Access Compliance Report

Public Rights-of-Way

(Curb Ramps)

Intersection ID: 7604	Main Street: KISMET_DR	Cross Street: SULLINS_RD	Location:	N
ADA ID: C8EEFF76F2A2	Ramp Type: Perp	Initial Pass/Fail: Fail	Overall Compliance: No	Severity Score: 22.5
Codes/Mitigation Info/Possible Solution		Field Measurements/Component Compliance

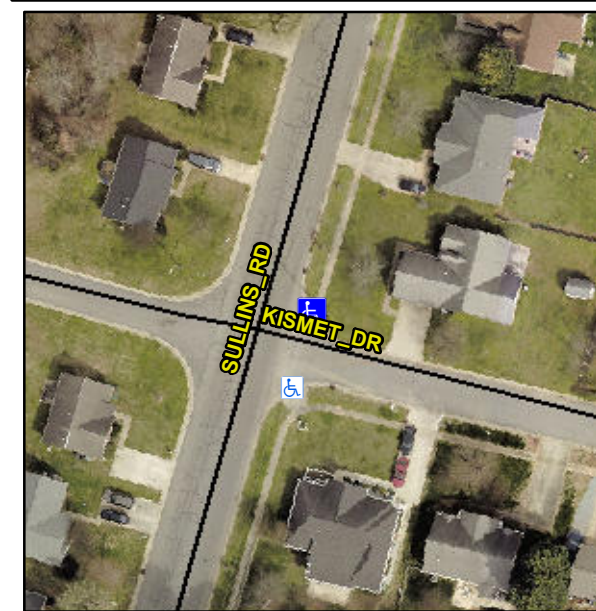
Not Found, R304.5.1, R304.2.2, R304.5.3

Compliance	Description	Data	Compliance	Description	Data
N/A	Ramp Length (in)	48.0	No	Ramp Slope (%)	8.6
No	Ramp Width (in)	47.0	No	Ramp XSlope (%)	2.3
N/A	Flare Type LT	N/A	N/A	Flare Type RT	N/A
N/A	Flare Slope LT (%)	N/A	N/A	Flare Slope RT (%)	N/A
N/A	Flare Traversable LT?	N/A	N/A	Flare Traversable RT?	N/A
N/A	Landing Length (in)	N/A	N/A	DWS Provided?	N/A
N/A	Landing Width (in)	N/A	N/A	DWS Contrast?	N/A
N/A	Landing Slope (%)	N/A	N/A	DWS Length (in)	N/A
N/A	Landing X Slope (%)	N/A	N/A	DWS Full Width?	N/A
N/A	Landing Curb? (Y/N)	N/A	N/A	DWS Offset (in)	N/A
N/A	Shared Landing?	N/A			
N/A	Gutter Ponding?	N/A	N/A	Gutter Slope (%)	N/A
N/A	Gutter Lip Ht (in)	N/A	N/A	Gutter X Slope (%)	N/A
N/A	Painted X Walk1?	No	N/A	Painted X Walk2?	N/A
	X Walk 1 Direction	To S		X Walk 2 Direction	N/A
N/A	X Walk 1 Width (in)	N/A	N/A	X Walk 2 Width (in)	N/A
	X Walk 1 Slope (%)	1.6		X Walk 2 Slope (%)	N/A
	X Walk 1 X Slope (%)	3.1		X Walk 2 X Slope (%)	N/A

Remove & Replace Entire Ramp.
